DESIGN DATA DOCUMENTATION AND EVALUATION OF ANOMALOUS CONCRETE SHAFTS

SE CONNECTOR, BR. NO.56-802F (ID-10) BACKUP DOCUMENTATION

Subject: Southeast Connector - Potential Pile Shaft Anomaly at Bent 15 – Structural Assessment

Subject: Lake Hodges Bridge Structural Assessment with Potential Pile Shaft Anomaly at Pile 1 of Abutment 6 - Revised

Xsection results for discounted wedge oriented along tube no. 2

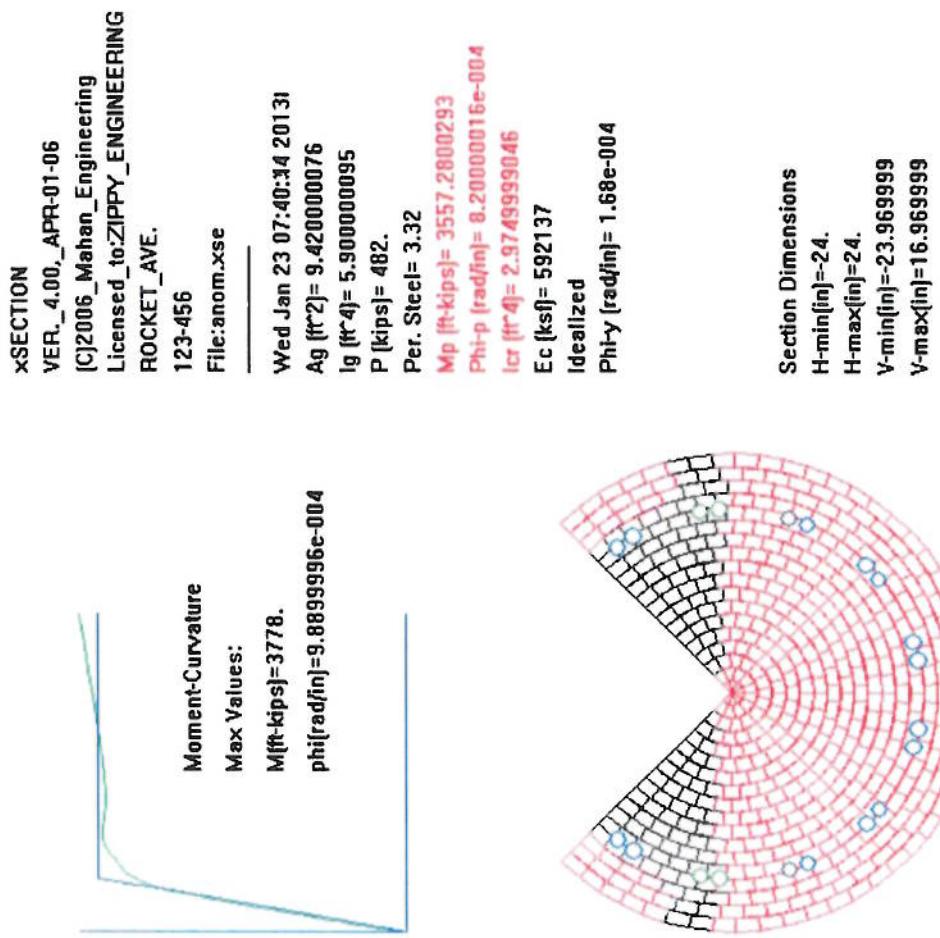
Analysis was done to determine the reduced moment capacity of one pile section assuming that the portion of the concrete pile represented by the assumed anomalous zone was one-quarter pie-shaped (a 25% reduction of concrete pile area and corresponding compression reinforcement). The results of this analysis showed that the pile moment capacity would be reduced to a minimum of 58% of its original design capacity. This would reduce the lateral capacity of the abutment 18-pile system to $(0.58*1+1.0*17)/18 = 97.7\%$ of its original design. Based on the original structural design calculations, the final structural lateral design capacity of the pile shafts exceeded the necessary lateral structural design demand by 18%. Therefore, it can be seen that the lateral design capacity of the abutment system would still exceed the lateral design demand.

Worst case scenario w/discounted wedge along compression side

ALL DIMENSIONS ARE IN
METERS UNLESS OTHERWISE SHOWN
SIGN PLAN
(LOCATION 19)
NO SCALE

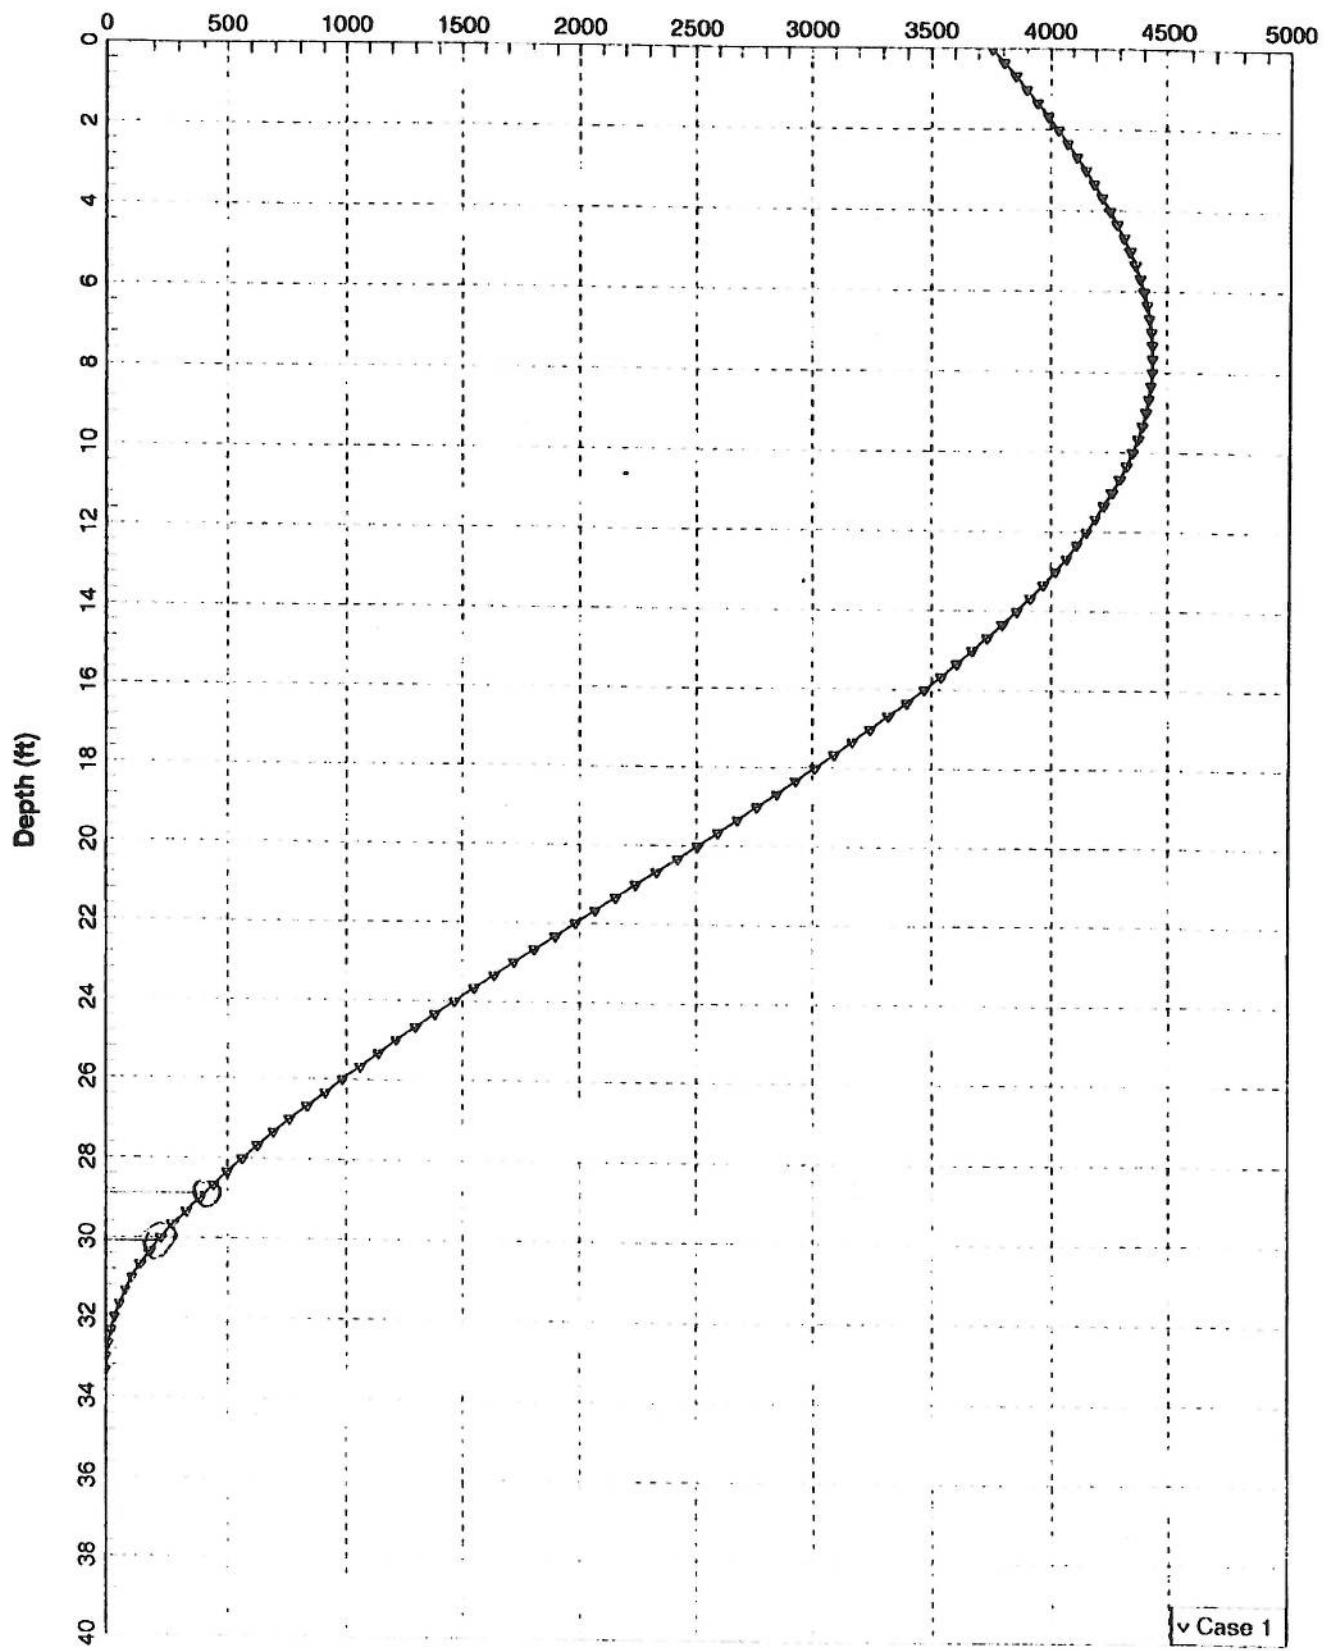
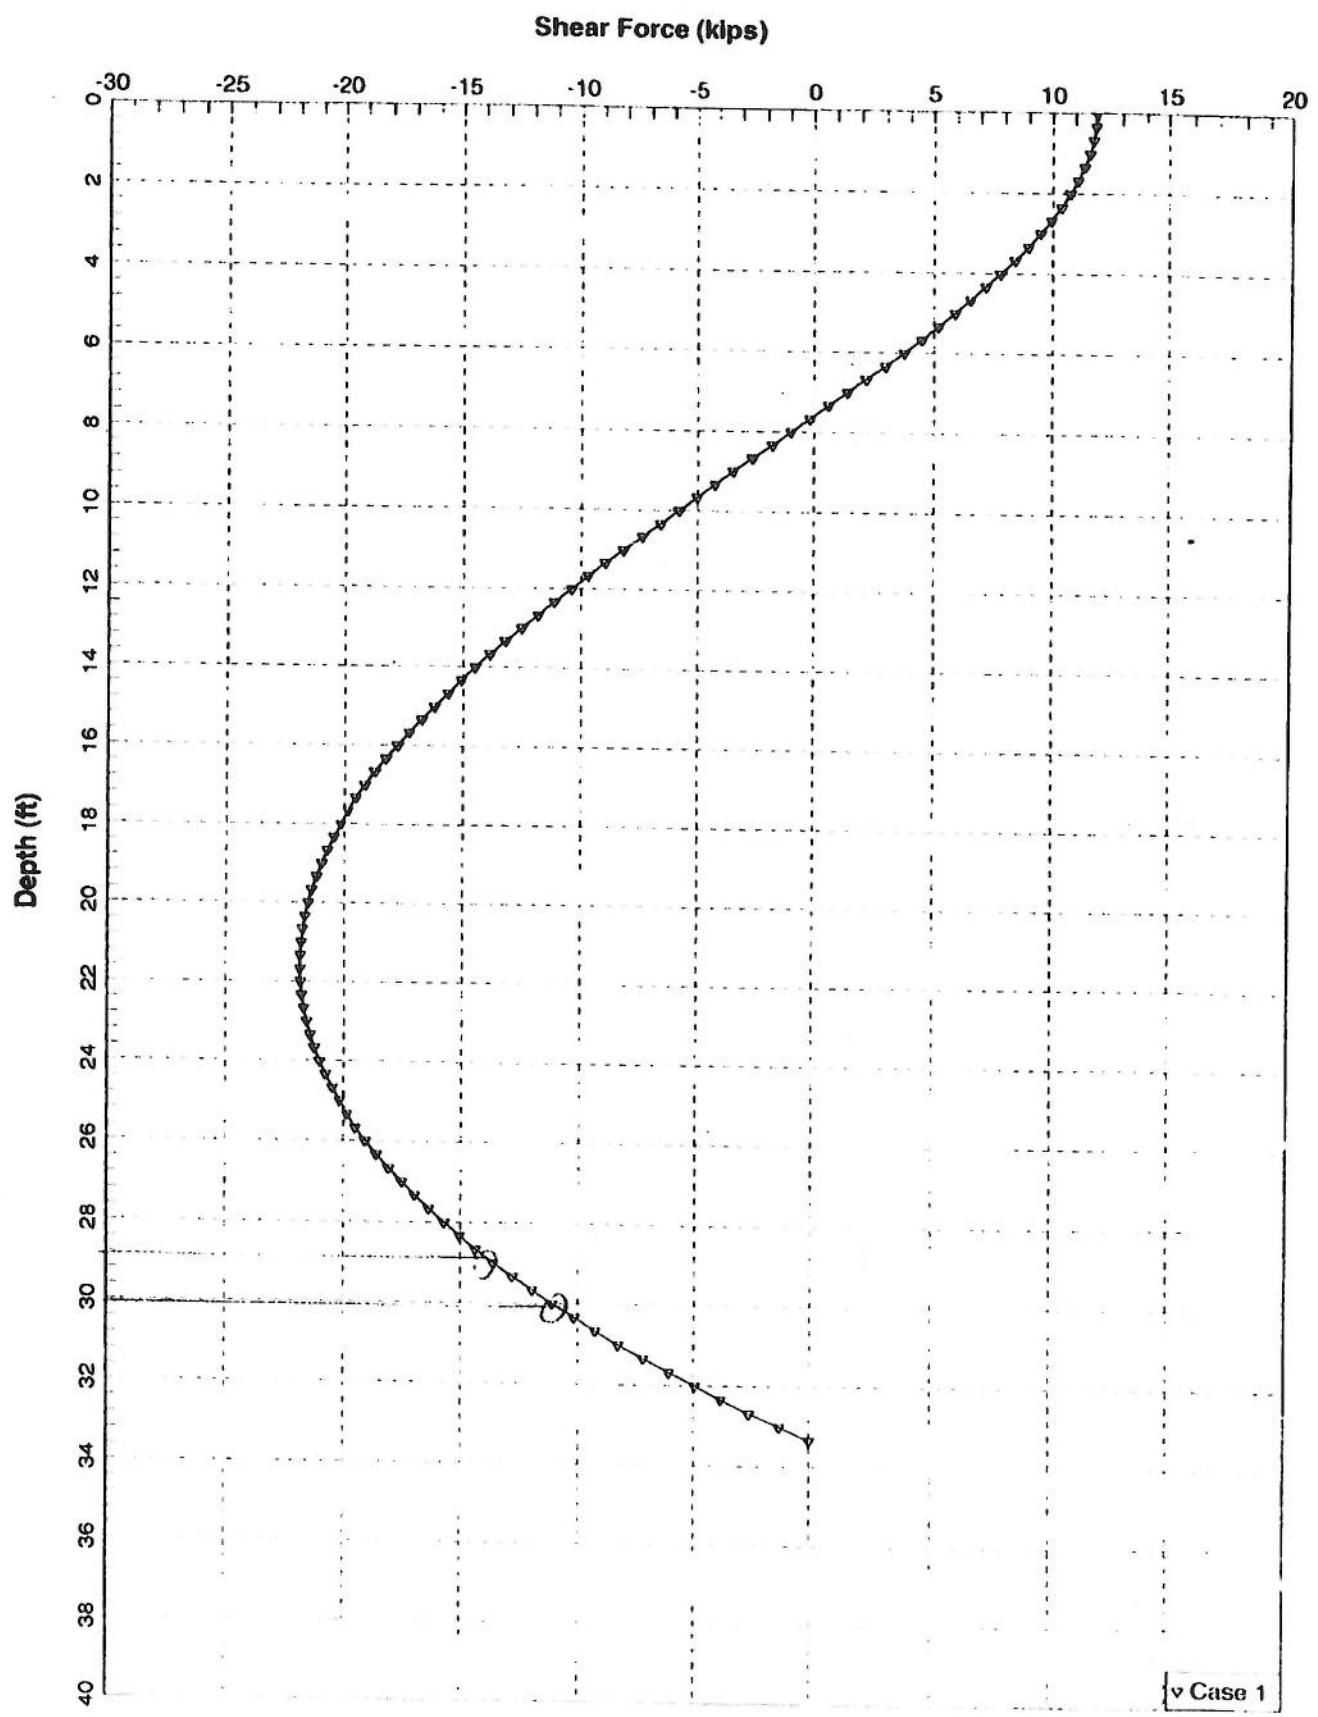
Recommendation: Based on the analysis and factor of safety listed above, the pile is structurally adequate.
